Information Request 11.1

Acoustic Environment

Effects of Noise on Wildlife

Air Blast Assessment

Town of Marathon Noise Sensitive Receptor Plan

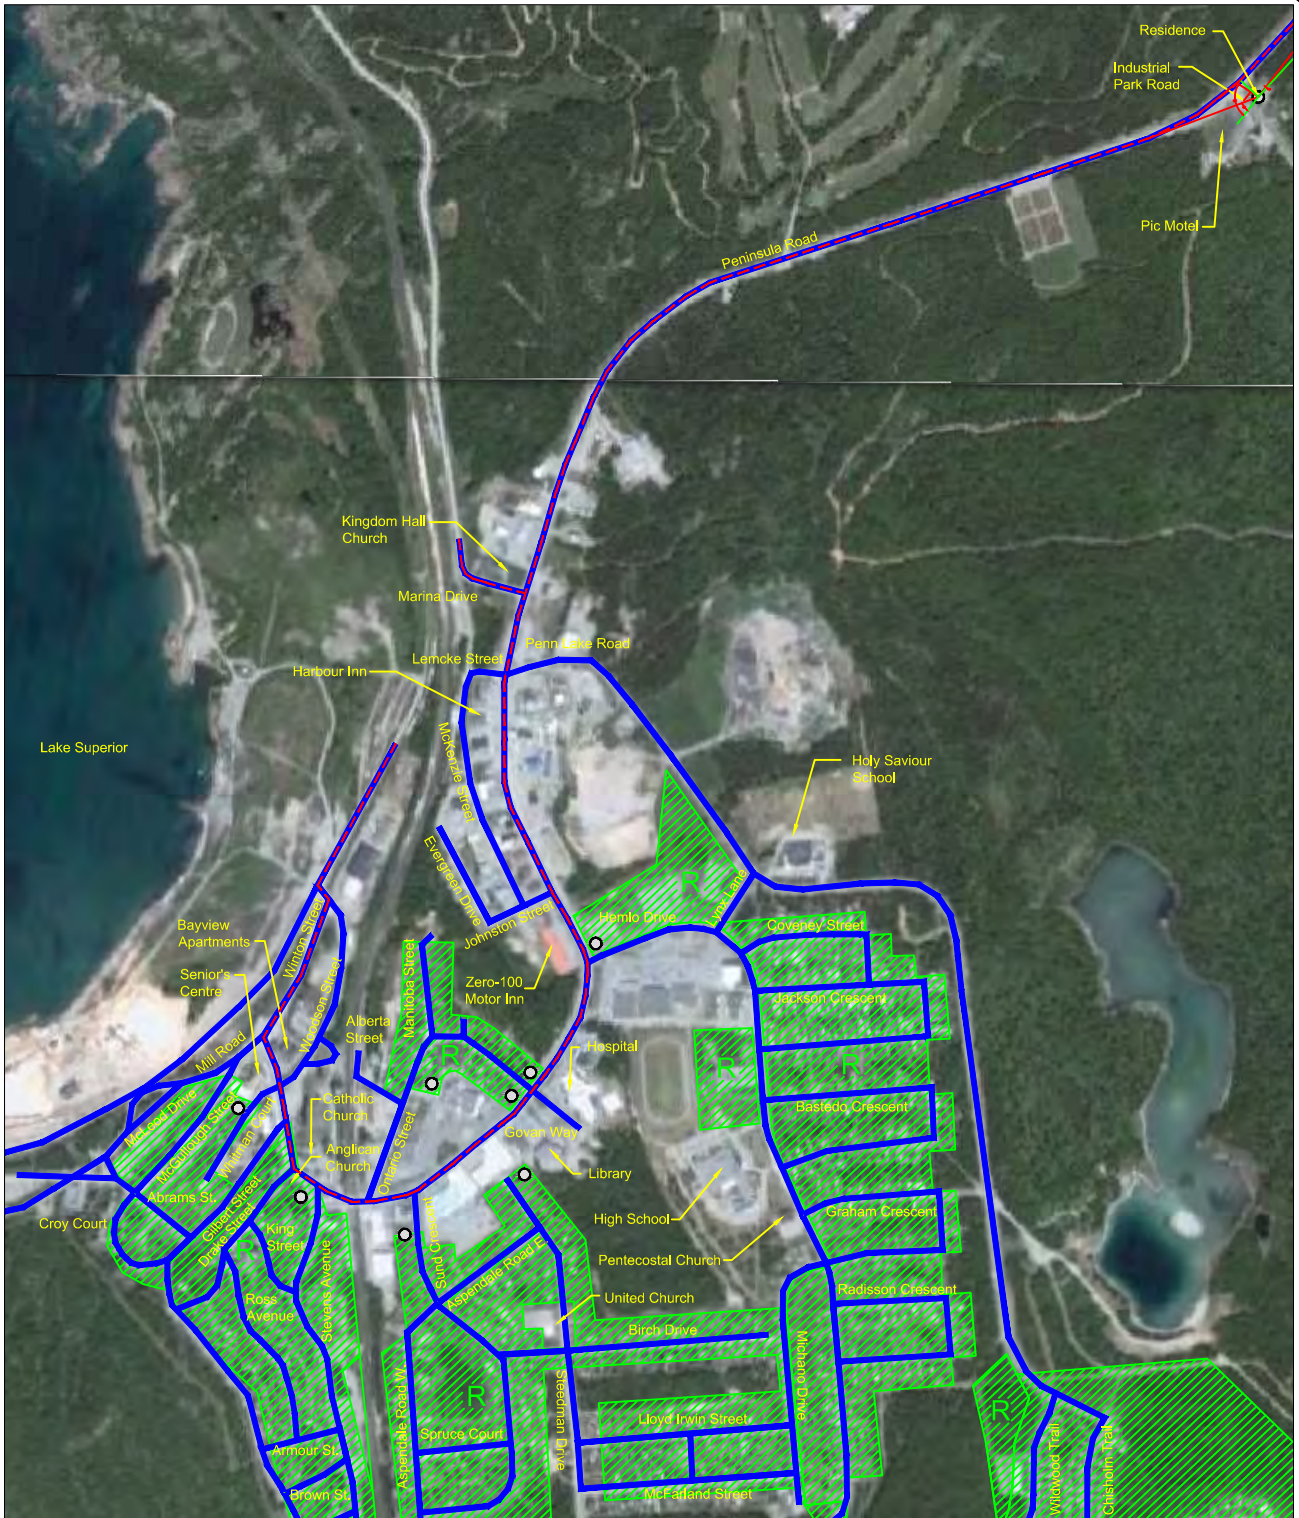
Provide an assessment of the potential environmental effects of increased noise in the local study area, along haul routes and at the rail load-out facility due to truck-related road traffic, assuming the production of an iron concentrate. Identify additional mitigation, if necessary, and update the significance conclusions.

The noise sensitive receptors chosen for comparison in the Town of Marathon included the residence on the corner of Peninsula Road and Industrial Park Road and the second floor of the Senior's Centre. Two proposed travel routes were assessed: One route follows Peninsula Road and Marina Drive and the second follows Peninsula Road, Stevens Avenue and Winton Street. See attached Figure 6 from SID#13. The residence will be

Location (Noise Parameter)	Predicted Result	
	STNM	ORNAMENT
May's Gifts Traffic Background (Leq1)	53.4 dBA	56.4 dBA
May's Gifts Traffic Background (Leq16)	55.5 dBA	58.9 dBA
May's Gifts Project Traffic (Leq16)	55.6 dBA	59.0 dBA
Town of Marathon Residence Traffic Background	56.1 dBA	55.0 dBA
Town of Marathon Residence Project Traffic (Leq16)	57.3 dBA	57.0 dBA
Second Floor of Senior's Center Traffic Background	48.6 dBA	* n/a
Second Floor of Senior's Center Project Traffic	53.1 dBA	55.6 dBA
Notes: * Traffic was less than ORNAMENT's 40 vehicle per hour threshold.

According to MOE qualitative ratings, the increased sound levels ranging from 1-3 dB are insignificant and results are considered comparable. Based on the increase from background sound levels, the results presented by STNM and ORNAMENT both suggest the second proposed rail loadout route will have a significant impact on the Senior's Centre.

As noted above, given that SCI has decided to forego the production of iron ore concentrate, the direct comparison provided above is considered quite conservative due to the inclusion of traffic associated with the transportation of iron ore concentrate into the Town of Marathon.
